Richfield Planning Commission Agenda

a. Public hearing to consider a request by Minnesota Independence College & Community for a rezoning, Conditional Use Permit, Preliminary Plat, and variances.

MICC ARC Letter
11-21-25
Page 4

Encl: Engineering plan mark-ups & General Fire Protection Comments

OVERALL SITE MATERIAL PLAN

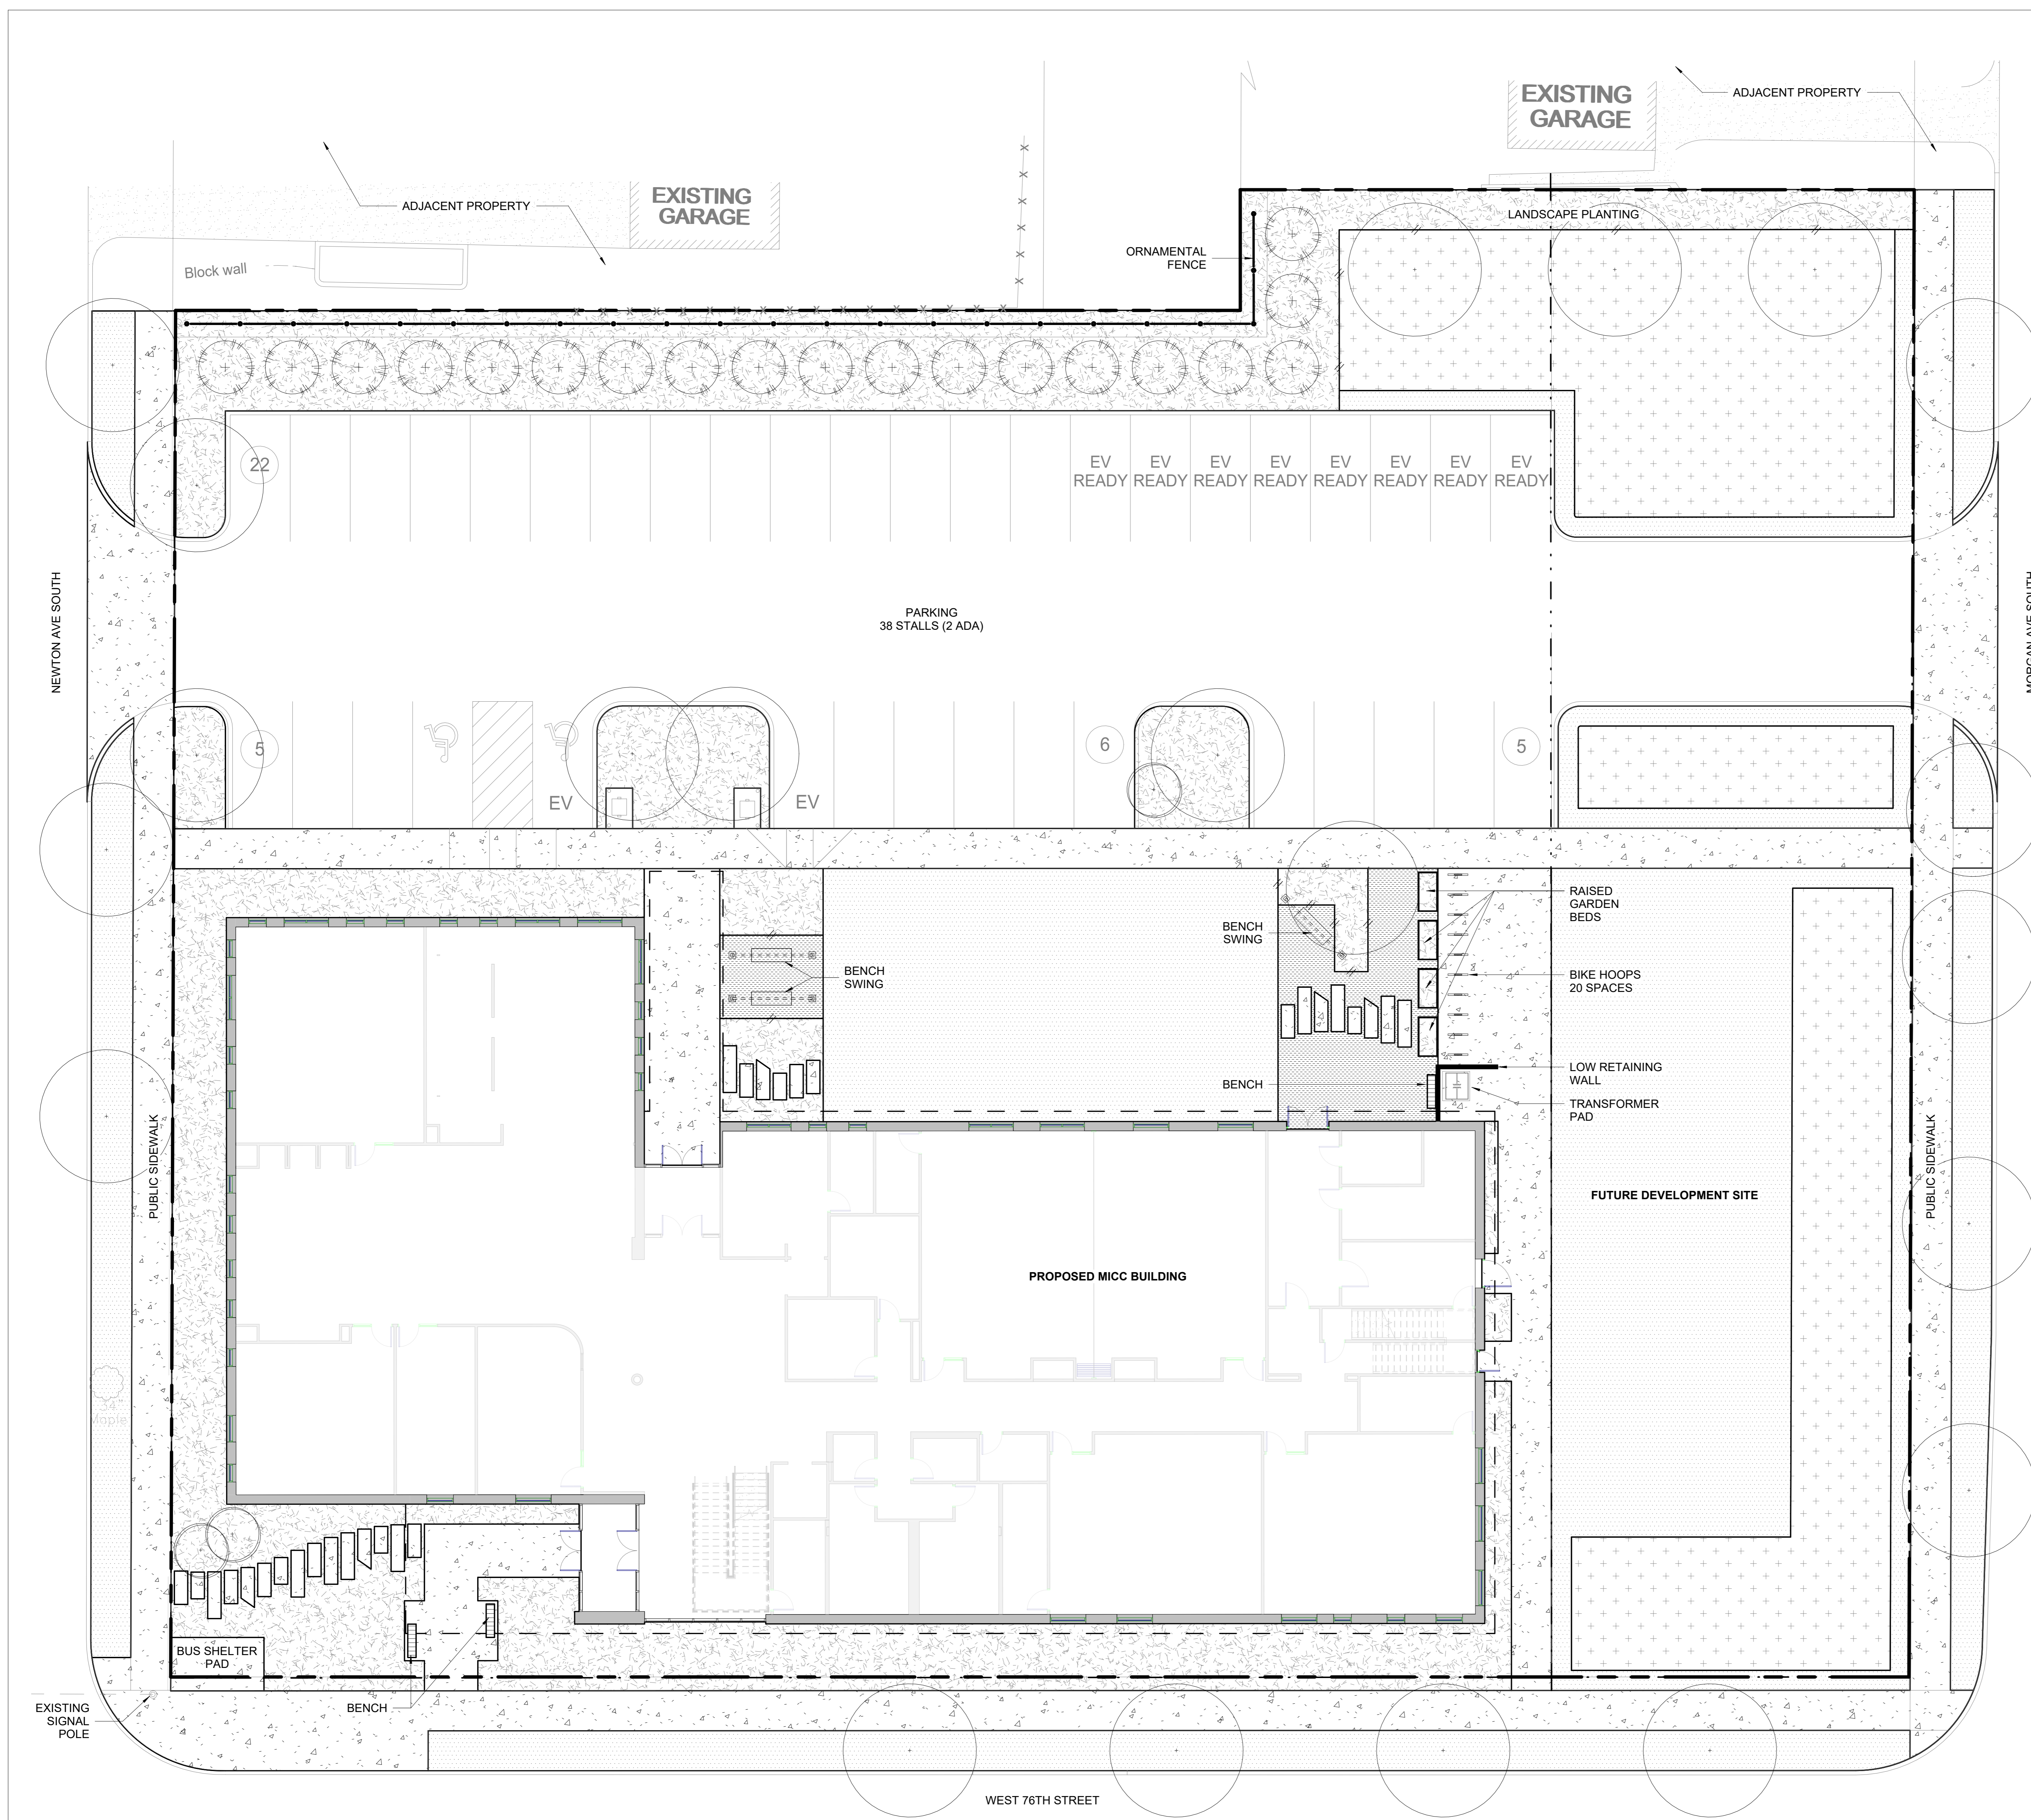
Strongly recommend salt tolerant turf and vegetation along 76th St. Consult with City staff for approved boulevard trees.
